Access Compliance Report

Public Rights-of-Way

(Curb Ramps)

Intersection ID: 11799	Main Street: MECKLENBURG_AV	Cross Street: NORCROSS_PL	Location:	S
ADA ID: 68870FCFFAE8	Ramp Type: Directional1	Initial Pass/Fail: Pass	Overall Compliance: No	Severity Score: 5

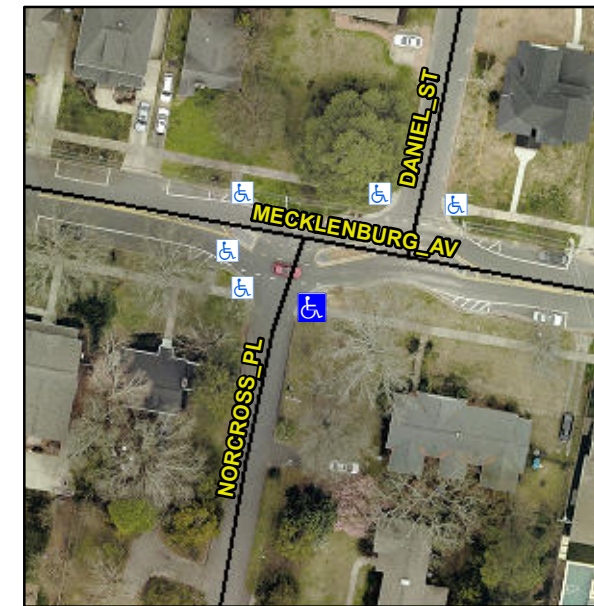
R304.5.3, R305.2, R302.7, R304.5.4

Compliance	Description	Data	Compliance	Description	Data
N/A	Ramp Length (in)	168.0	Yes	Grade Break?	Yes
Yes	Ramp Width (in)	62.0	No	Grade Break Slope (%)	5.5
Yes	Ramp Slope (%)	7.2	Yes	Grade Break XSlope (%)	0.1
Yes	Ramp XSlope (%)	0.8			
Yes	Flare Type LT	N/A	Yes	Flare Type RT	N/A
N/A	Flare Slope LT (%)	N/A	N/A	Flare Slope RT (%)	N/A
N/A	Flare Traversable LT?	No	N/A	Flare Traversable RT?	No
Yes	Landing Length (in)	54.0	Yes	DWS Provided?	Yes
Yes	Landing Width (in)	59.5	Yes	DWS Contrast?	Yes
Yes	Landing Slope (%)	1.1	Yes	DWS Length (in)	24.0
Yes	Landing X Slope (%)	0.4	Yes	DWS Full Width?	Yes
N/A	Landing Curb? (Y/N)	N/A	No	DWS Offset LT (in)	4.0
N/A	Shared Landing?	No	Yes	DWS Offset RT (in)	31.0
No	Gutter Ponding?	Yes	No	Gutter Slope (%)	8.3
Yes	Gutter Lip Ht (in)	0.0	Yes	Gutter X Slope (%)	0.9
N/A	Painted X Walk1?	No		Road Slope (%)	3.3
	X Walk 1 Direction	To W		Road X Slope (%)	3.5
	X Walk 1 Width (in)	N/A		Clear Space?	Yes

**Remove & Replace Entire Ramp.
Remove & Replace Gutter.**
